TO: Bob Exstrom, Town of Parker
FROM: Stacey Nerger, Senior Planner
DATE: February 29, 2024
SUBJECT: Parker Town Hall Amendment 3 Lot 1 – Site Plan
Review Comments 02

Parker Town Hall Expansion

PARKER TOWN HALL EXEMPTION PLAN AMD3 L1 SITE PLAN SUBMITTAL

SITE PLAN

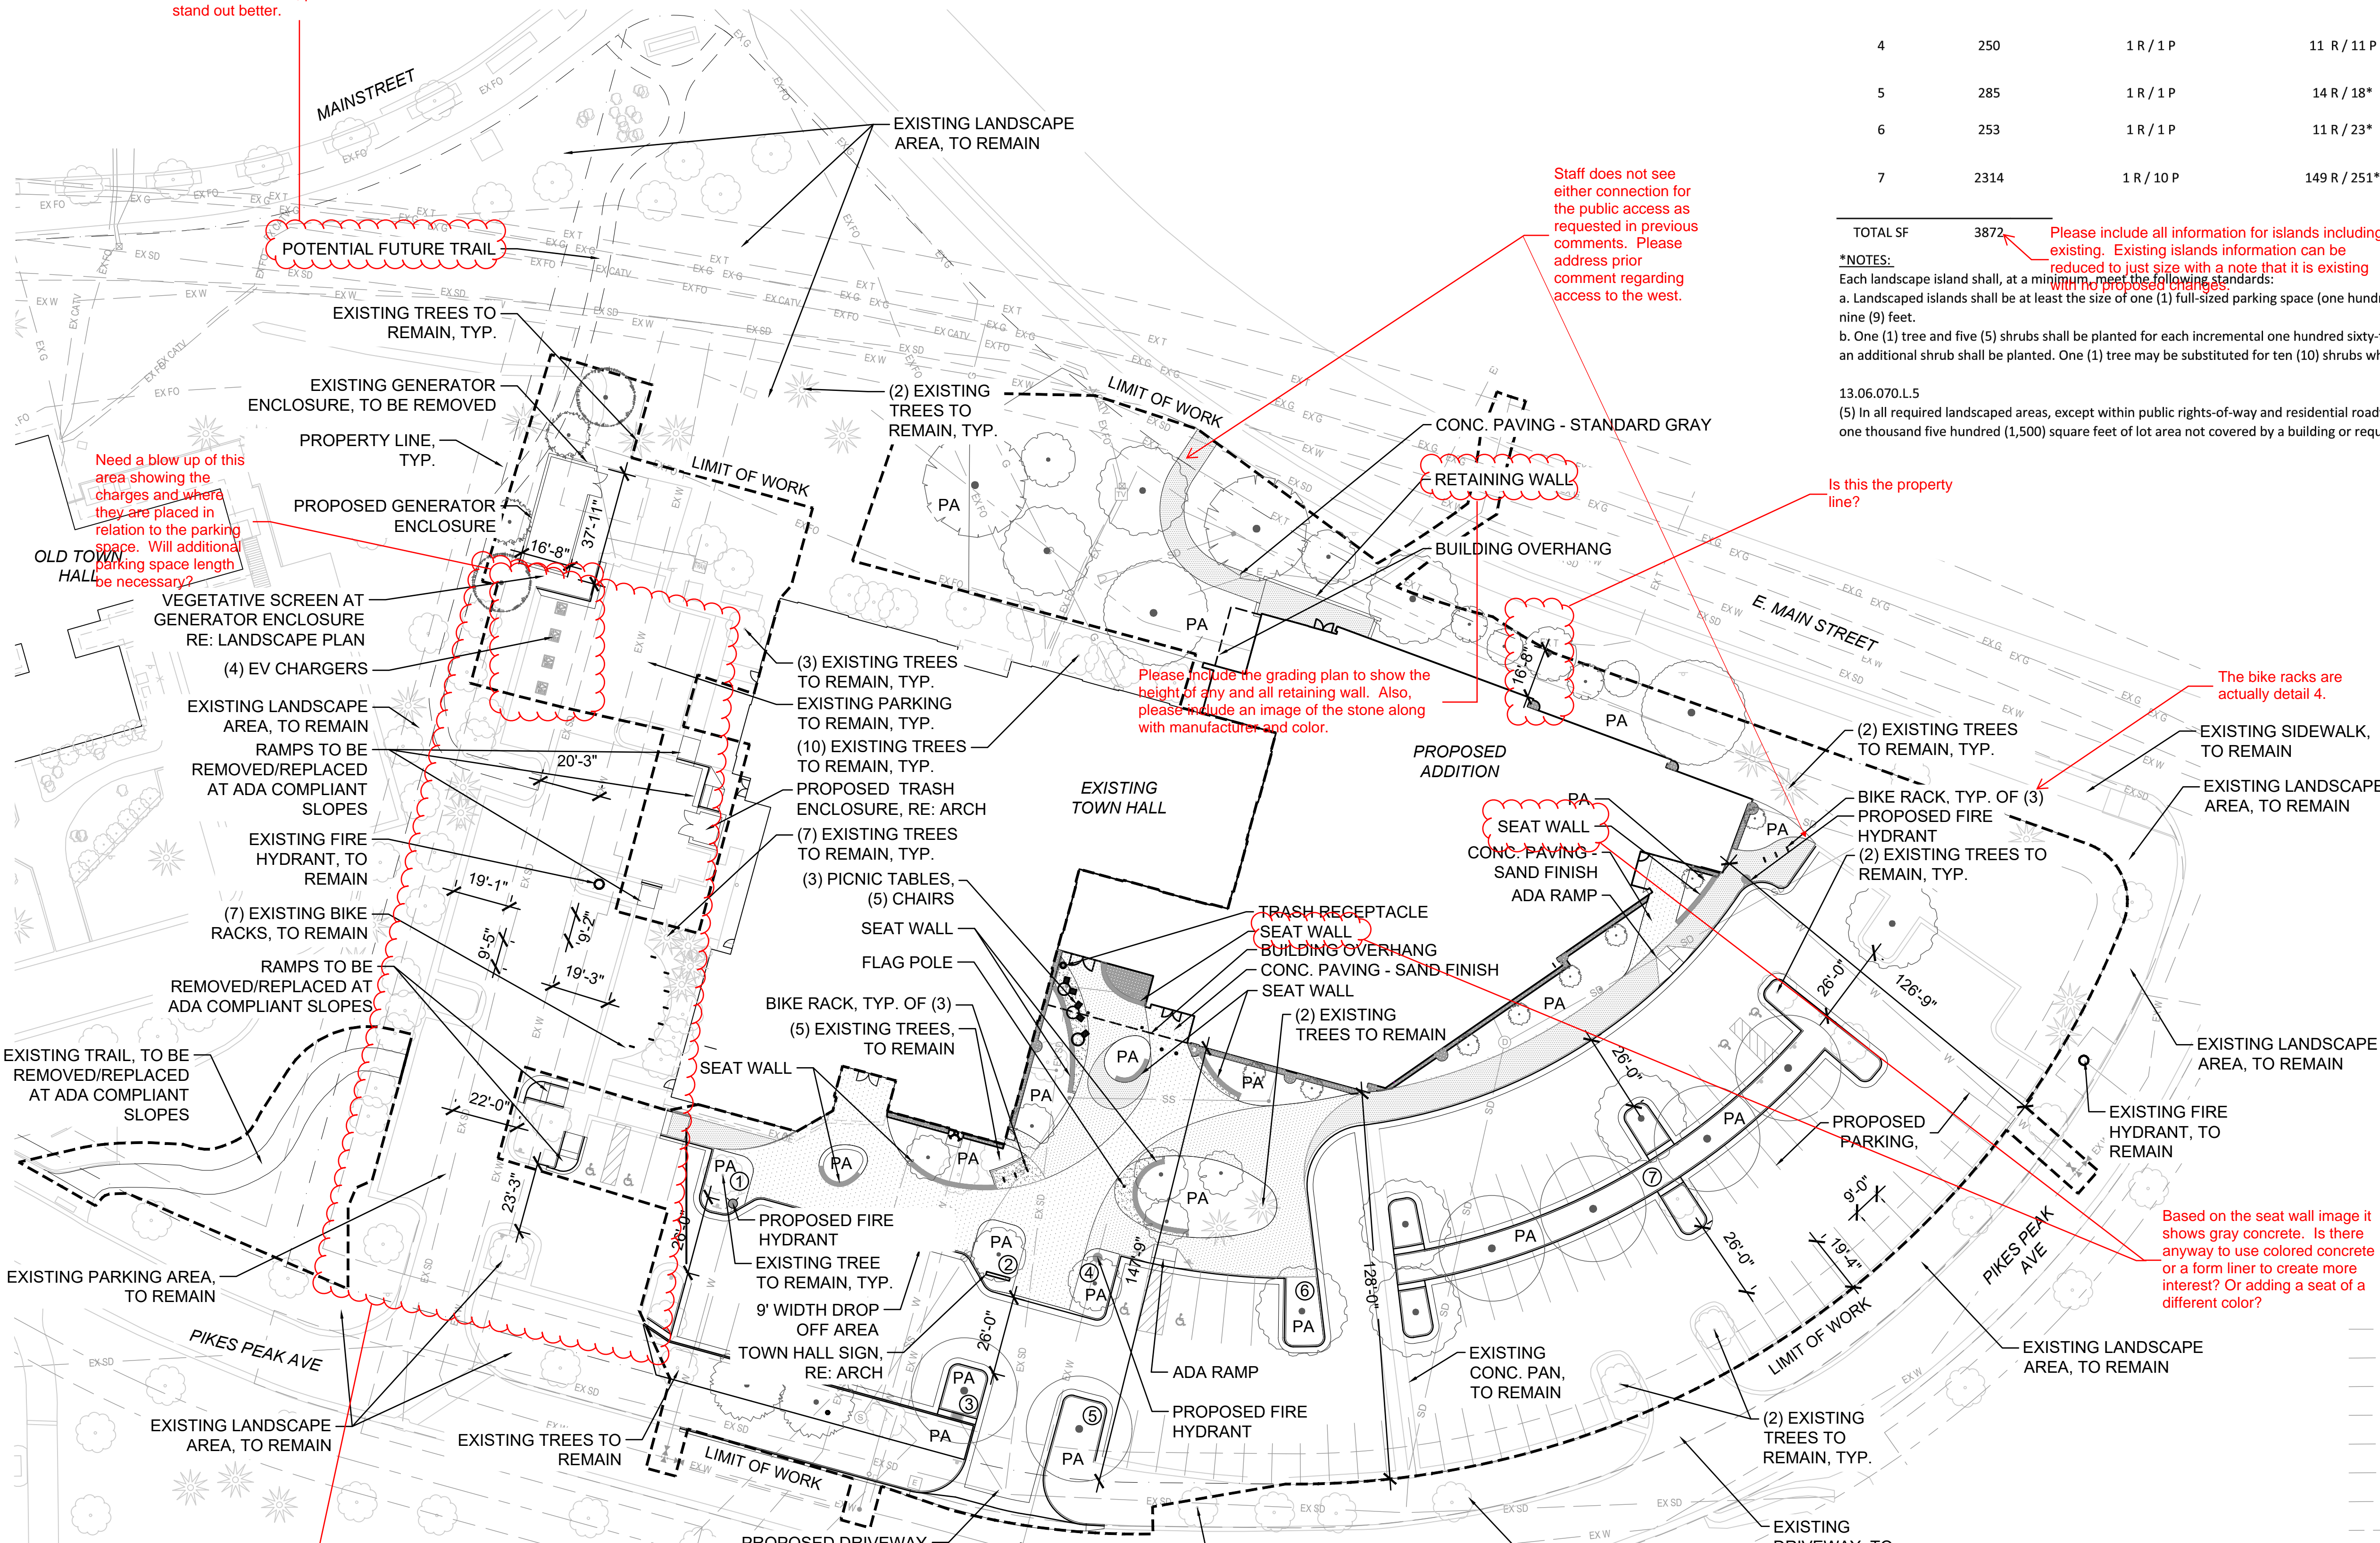
Change to "Future Pedestrian Connection". Also, please bold to stand out better.

Need a blow up of this area showing the charges and where they are placed in relation to the parking space. Will additional parking space length be necessary?

Staff does not see either connection for the public access as requested in previous comments. Please address prior comment regarding access to the west.

Please include the grading plan to show the height of any and all retaining walls. Also, please include an image of the stone along with manufacturer and color.

To demonstrate that the parking listed in the table is provided, please show all spaces on the Site Plan.

PHOTOMETRIC SITE PLAN

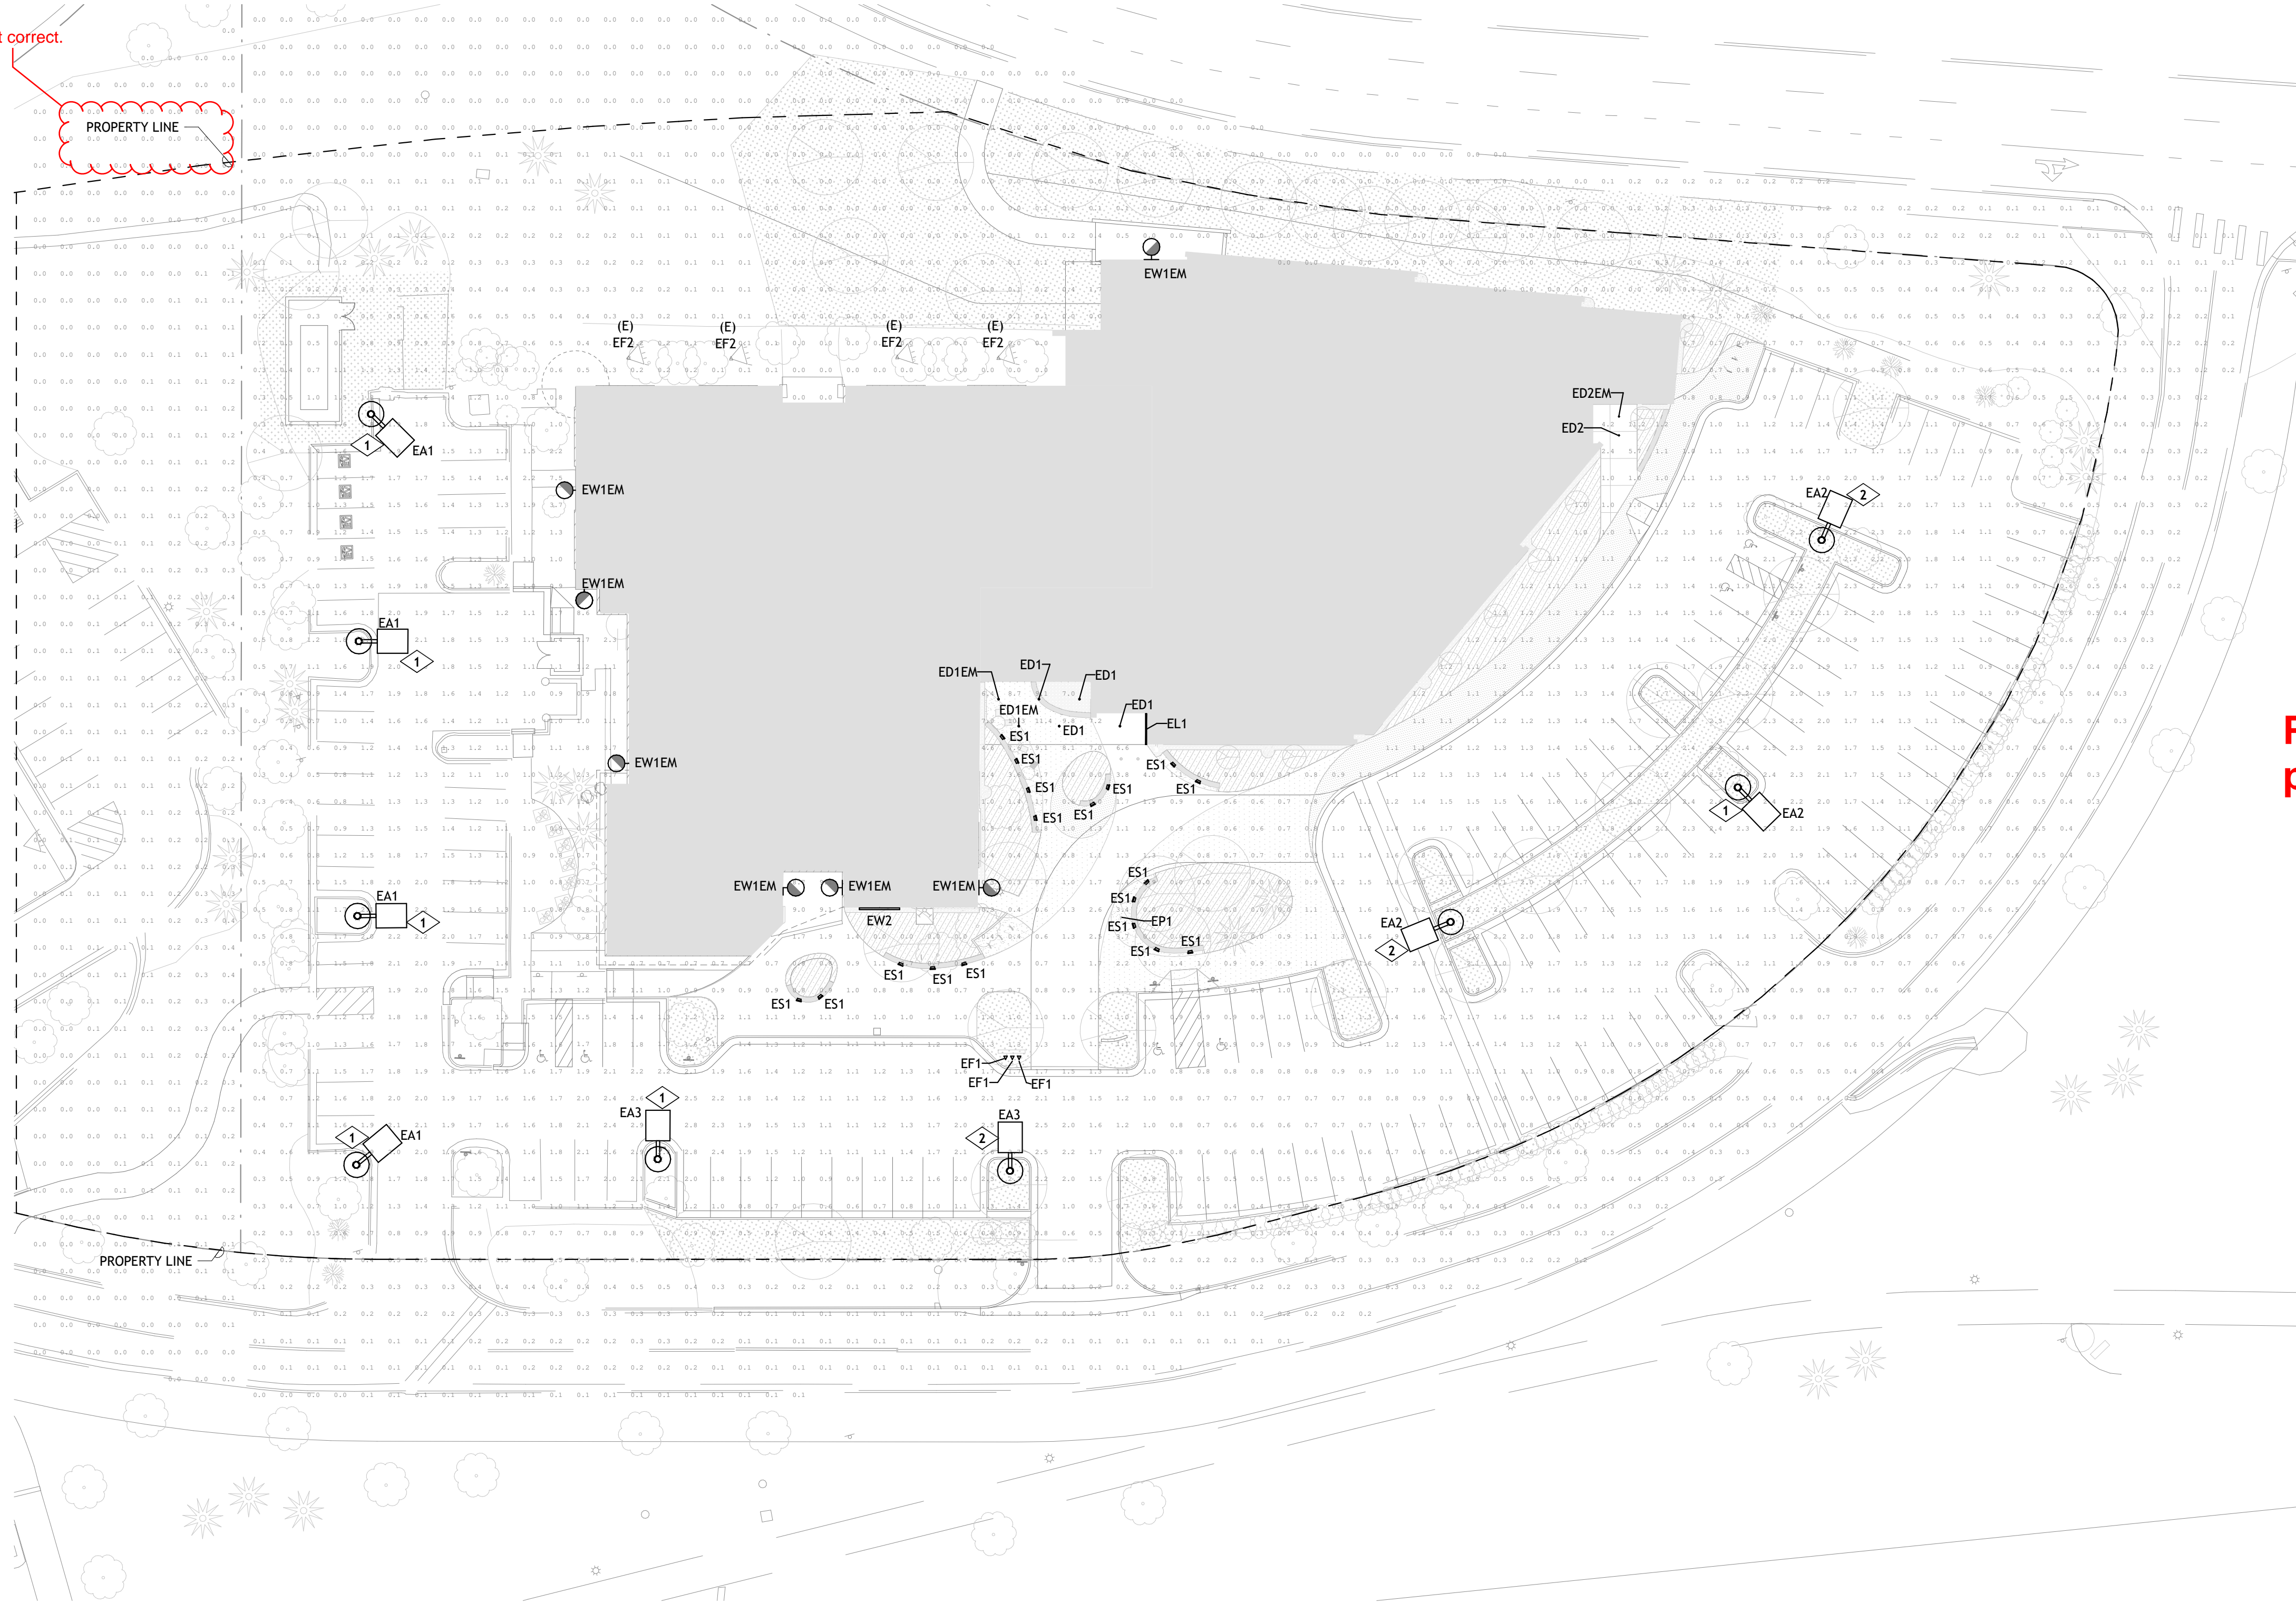
Please include an image of how the parking lot lights will be constructed.

This is not correct.

Move this page to be located with the landscape plans.

TREE CONSERVATION PLAN

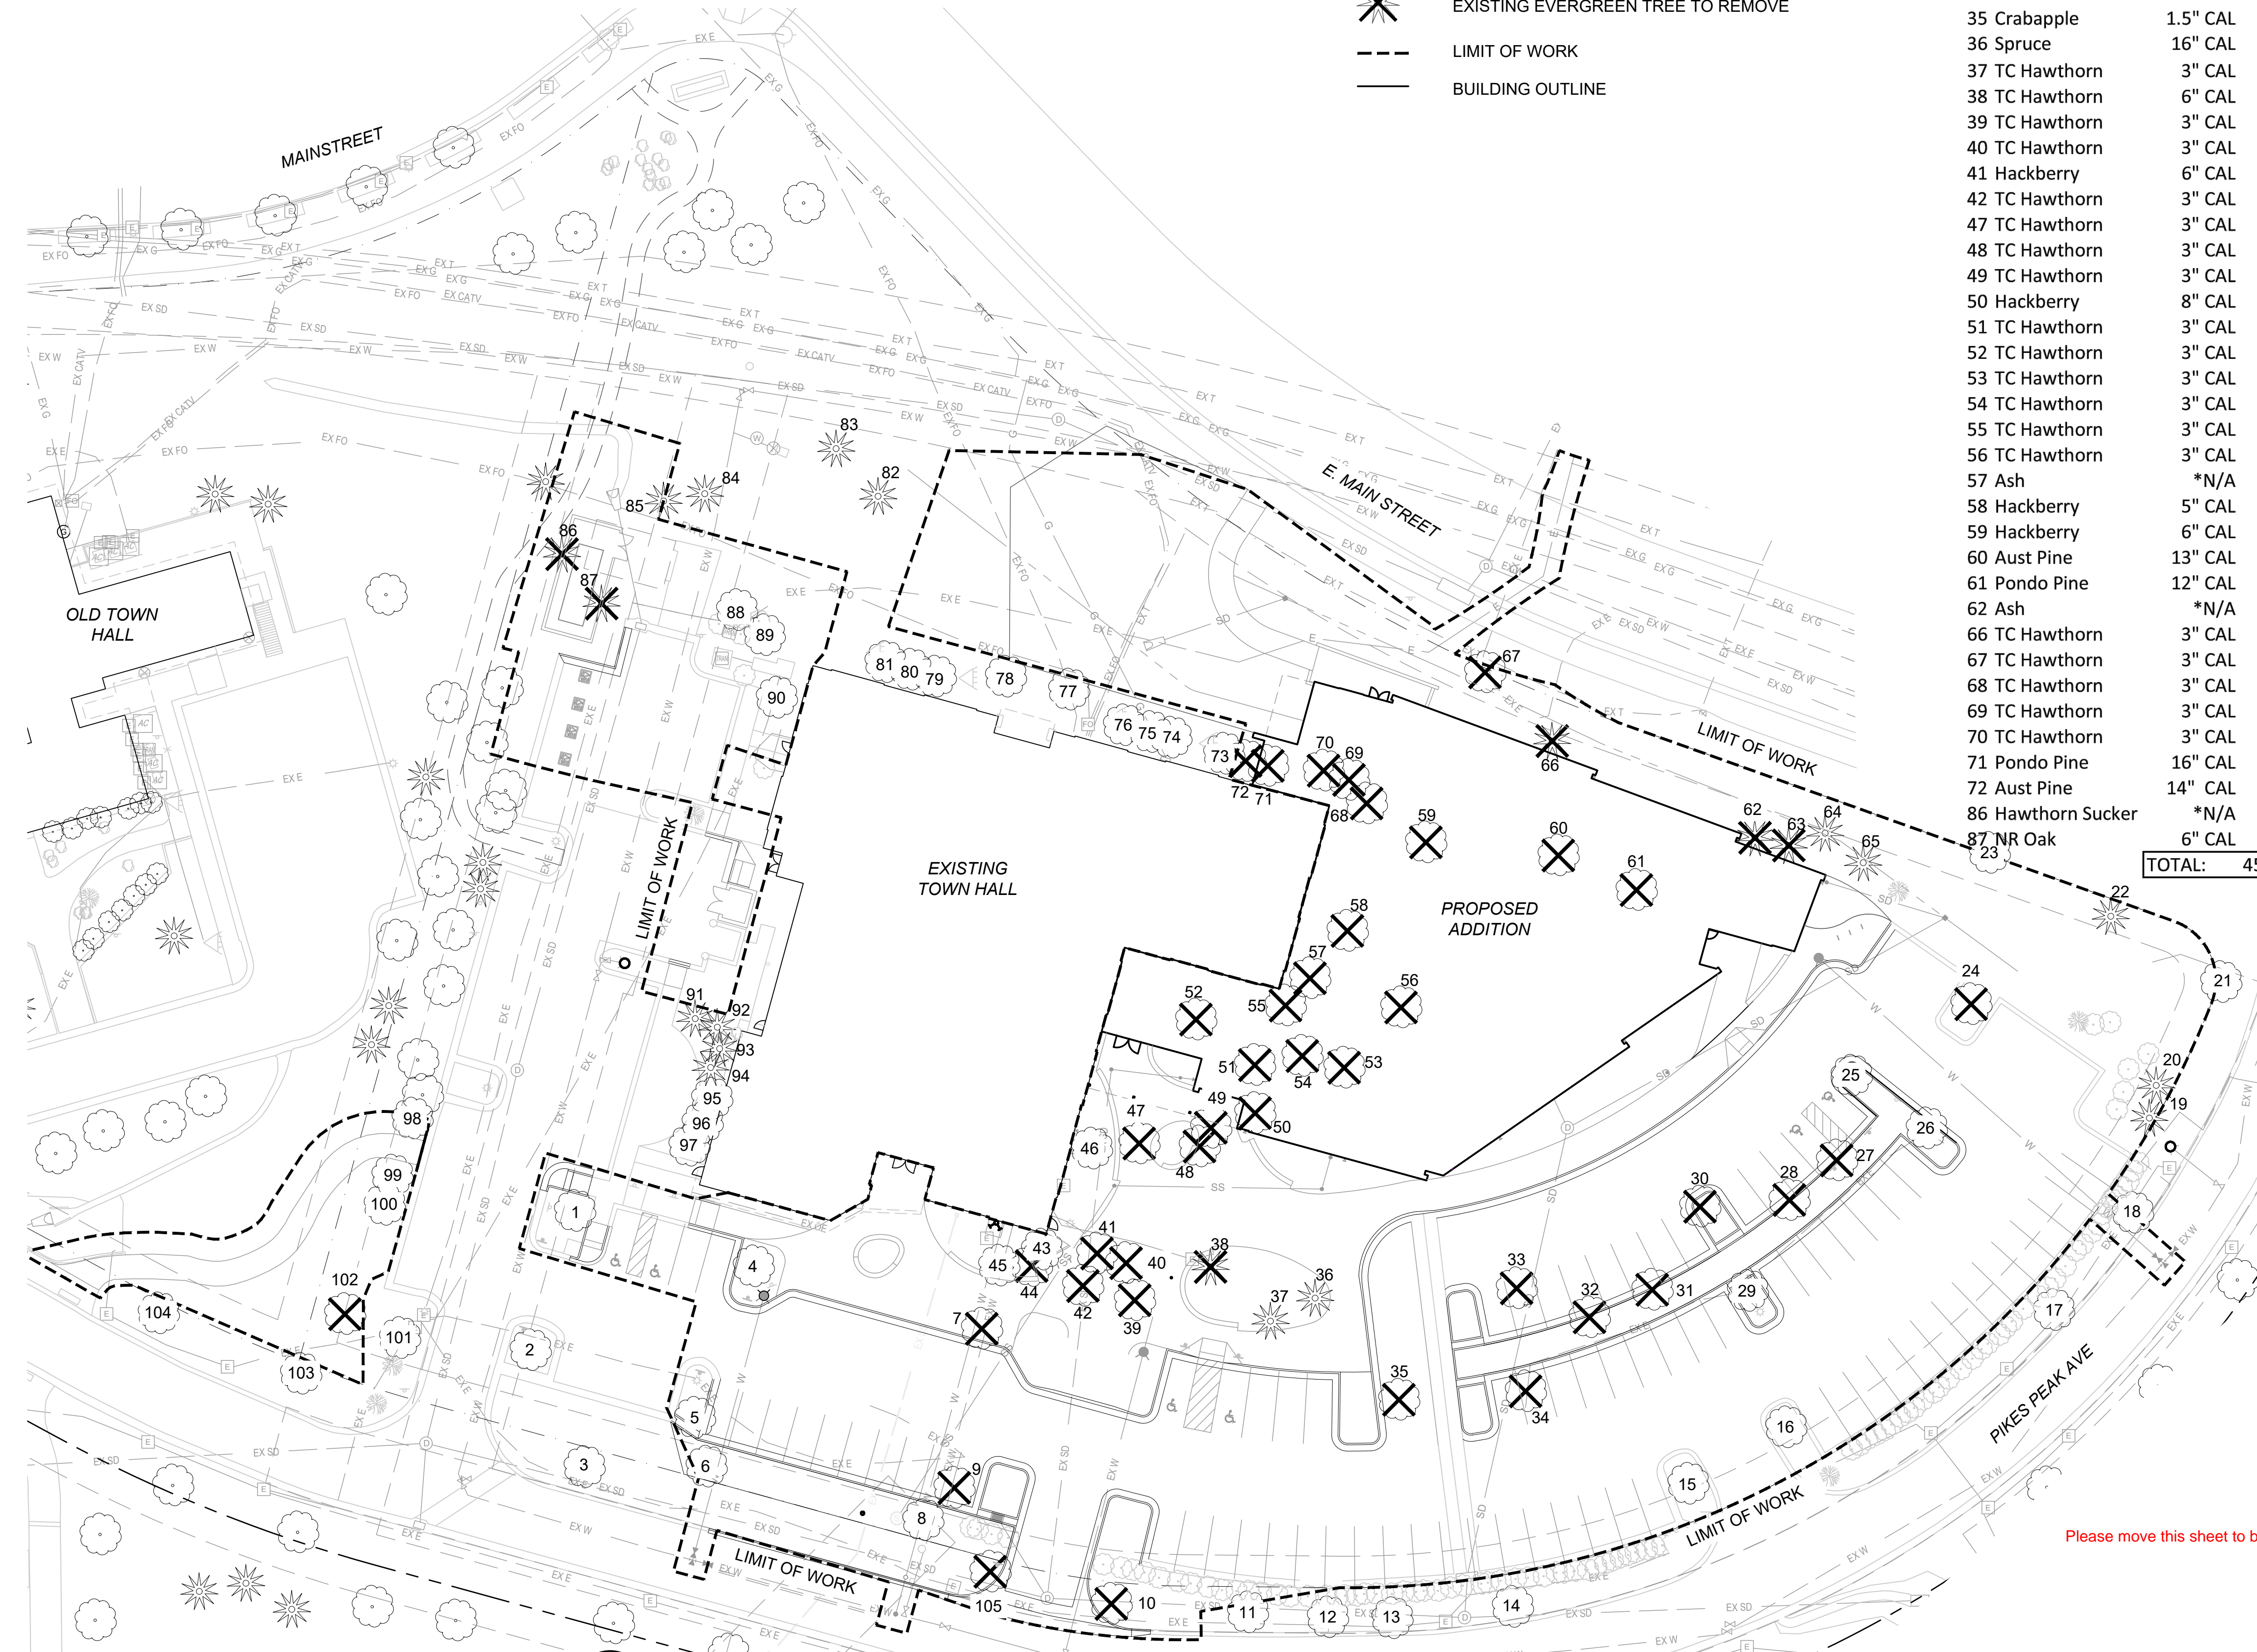
This amount will either need to be paid to the Town or can be mitigated by adding additional trees (above what is required by code) to the Site Plan. If this will be paid, we need to work with Parks to determine how much money we have available to use.

Please move this sheet to be part of the landscape sheets.
